UNITED STATES PATENT AND TRADEMARK OFFICE

Office Action Summary

10/531,304

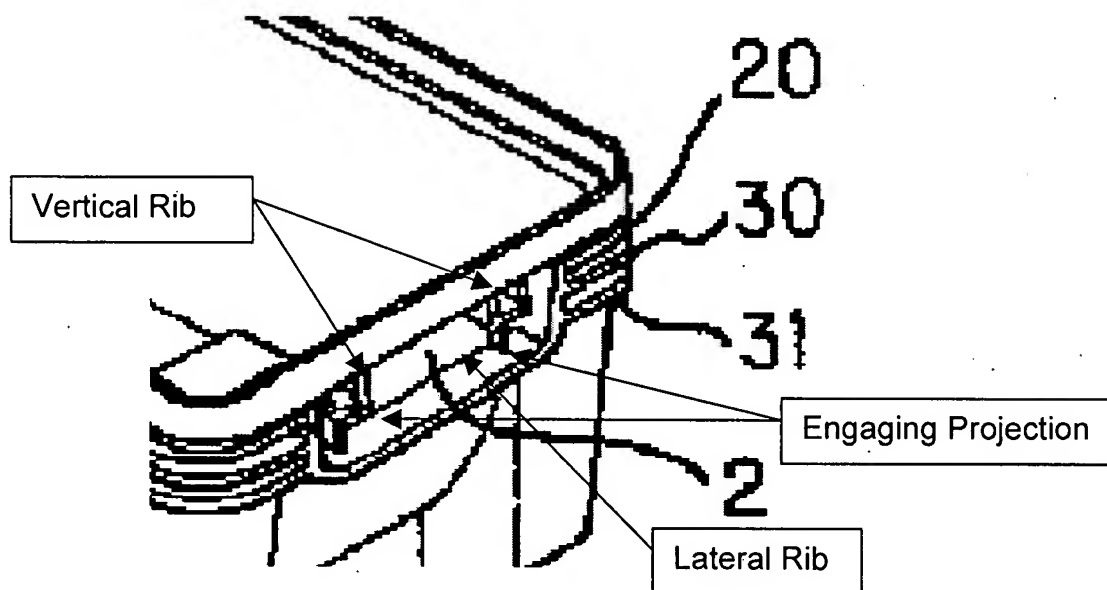
Claim 1: Ohori discloses a container comprising a container body 1, a container lid 2, a cassette 3, a cassette lid 8, an L-shaped flange 10, a first flange 20, and a second flange 30. Ohori further discloses a D-zone (portion with locking part 2), the D-

zone having a lateral rib and two engaging projections provided on interconnecting vertical ribs (see below).

Ohori functions as claimed. Ohori lacks, or does not expressly disclose, vertical ribs between the first and second flanges, the specific distance between the first and second flanges, or the recessed D-zone.

As to the recessed D-Zone, one of ordinary skill in the art, when observing Ohori, would note that the D-zone has a perimeter to distinguish it from flanges 20 and 30 (see Figure 1). Moreover, the side view of Figure 2 does not show any projecting components beyond the extent of flanges 20 and 30. In viewing these depictions, one of ordinary skill in the art would have found it beneficial and obvious to recess the D-zone (and thereby the lateral rib) in order to prevent any snagging portions extending beyond the extent of perimeter flanges 20 and 30. The drawings must be evaluated for what they reasonably disclose and suggest to one of ordinary skill in the art. *In re Aslanian*, 590 F.2d 911, 200 USPQ 500 (CCPA 1979). MPEP § 2125. It is proper to take account of the "inferences and creative steps that a person of ordinary skill in the art would employ." See *KSR Int'l Co. v. Teleflex Inc.*, 550 U.S. 1727, 1731, 82 USPQ2d 1385, 1396 (2007). See also *id.* at 1742, 82 USPQ2d at 1397 ("A person of ordinary skill is also a person of ordinary creativity, not an automaton.")
